Access Compliance Report

Public Rights-of-Way

Intersection ID: 15584	Main Street: W_T_HARRIS_BV	Cross Street: BONLYN_DR	Location: NE
ADA ID: 880773BA0789	Ramp Type: Para	Initial Pass/Fail: Fail	Overall Compliance: No
Codes/Mitigation Info/Possible Solution			Severity Score: 22.5
			Field Measurements/Component Compliance

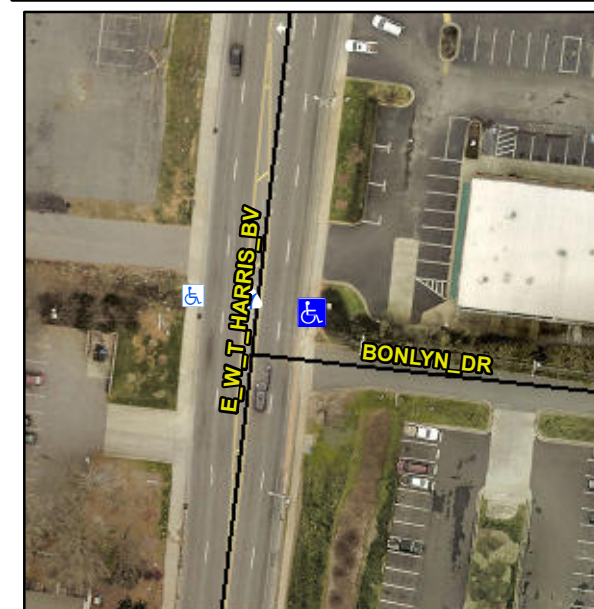
RT RP < 5%

R304.5.1, R304.3.2, R304.5.3

Compliance	Description	Data	Compliance	Description	Data
N/A	Ramp Length LT (in)	80.0	N/A	Ramp Length RT (in)	73.0
Yes	Ramp Width LT (in)	60.0	No	Ramp Width RT (in)	44.0
No	Ramp Slope LT (%)	9.7	Yes	Ramp Slope RT (%)	4.6
No	Ramp XSlope LT (%)	2.8	Yes	Ramp XSlope RT (%)	1.6
N/A	Landing Length (in)	N/A	N/A	DWS Provided?	N/A
N/A	Landing Width (in)	N/A	N/A	DWS Contrast?	N/A
N/A	Landing Slope (%)	N/A	N/A	DWS Length (in)	N/A
N/A	Landing X Slope (%)	N/A	N/A	DWS Full Width?	N/A
N/A	Landing Curb? (Y/N)	N/A	N/A	DWS Offset (in)	N/A
N/A	Shared Landing?	N/A			
N/A	Gutter Ponding?	N/A	N/A	Gutter Slope (%)	N/A
N/A	Gutter Lip Ht (in)	N/A	N/A	Gutter X Slope (%)	N/A
N/A	Painted X Walk1?	No	N/A	Painted X Walk2?	N/A
	X Walk 1 Direction	To W		X Walk 2 Direction	N/A
N/A	X Walk 1 Width (in)	N/A	N/A	X Walk 2 Width (in)	N/A
	X Walk 1 Slope (%)	6.7		X Walk 2 Slope (%)	N/A
	X Walk 1 X Slope (%)	1.8		X Walk 2 X Slope (%)	N/A
N/A	Ramp inside XWalk1?	N/A	N/A	Ramp inside XWalk2?	N/A

Remove & Replace Entire Ramp.
